**LEVY NUCLEAR PLANT, UNITS 1 AND 2
DOCKET NOS. 52-029 AND 52-030
SUPPLEMENT 2 TO RESPONSE TO NRC RAI LETTER 114 – SRP CHAPTER 8.0,
ELECTRICAL POWER**

Levy Nuclear Plant Units 1 and 2 (LNP) Supplement 2 Response to NRC Request for
Additional Information Letter No. 114 Related to SRP Chapter 8.0, Electrical Power,
Dated 8/14/2013

NRC Letter No.: LNP-RAI-LTR-114

Figure 1: Main AC Power Station Simplified One-Line Diagram

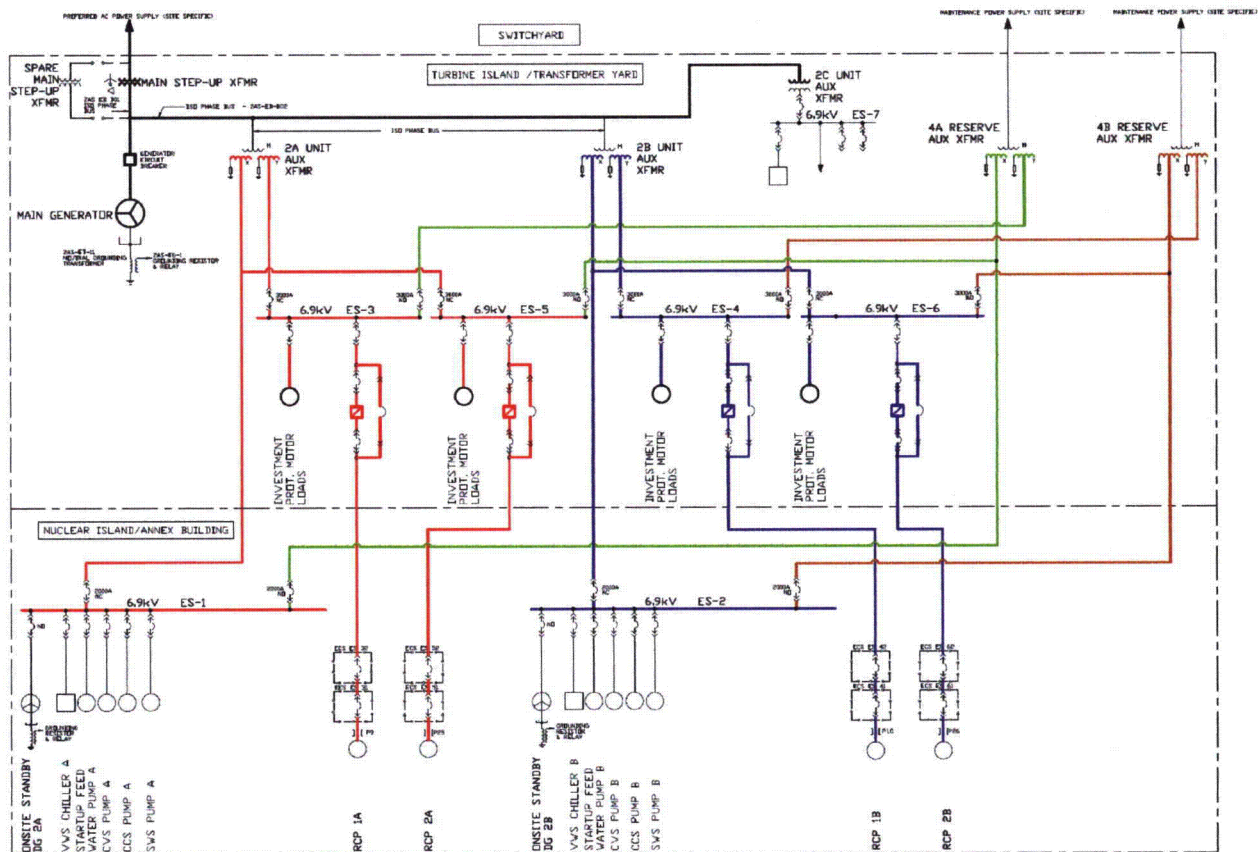
Identify which offsite circuit is credited to meet the GDC 17 requirements, considering the partial exemption for AP1000 plants.

The credited GDC 17 offsite power supply for the AP1000 plant is the Preferred AC Power Supply shown in Figure 1. The Preferred AC Power Supply is backfed through the three single phase main step-up transformers (MSUs), labeled "MAIN STEP-UP XFMR" as shown on Figure 1. The Preferred AC Power Supply is connected to the main generator bus and through the unit auxiliary transformers (UATs) 2A and 2B to the plant electrical distribution system.

Because of its passive safety features, the AP1000 passive plant does not require AC power to place the plant in a safe, stable shutdown condition. The AP1000 design was granted a partial exemption from GDC 17, specifically exempting the AP1000 plant from the requirement for a second GDC 17 credited offsite power source. Therefore, a second credited source of AC power from the power grid is not required. The Onsite Standby Power System (ZOS), powered by onsite standby diesel generators 2A and 2B, provides an alternate source of AC power to the plant electrical distribution system through medium voltage buses ES-1 and ES-2 for defense-in-depth shutdown loads.

Because of the partial GDC 17 exemption, the Maintenance Power Supply, fed through reserve auxiliary transformers (RATs) 4A and 4B, is not considered a credited GDC 17 power source. However, the medium voltage buses ES-1 and ES-2 can be manually aligned to receive power through the RATs. The medium voltage buses will automatically transfer from the UATs to the RATs in the event the credited Preferred AC Power Supply becomes unavailable due to an electrical fault at either the MSU, the isophase bus, the UATs or the 6.9 kV nonsegregated bus duct.
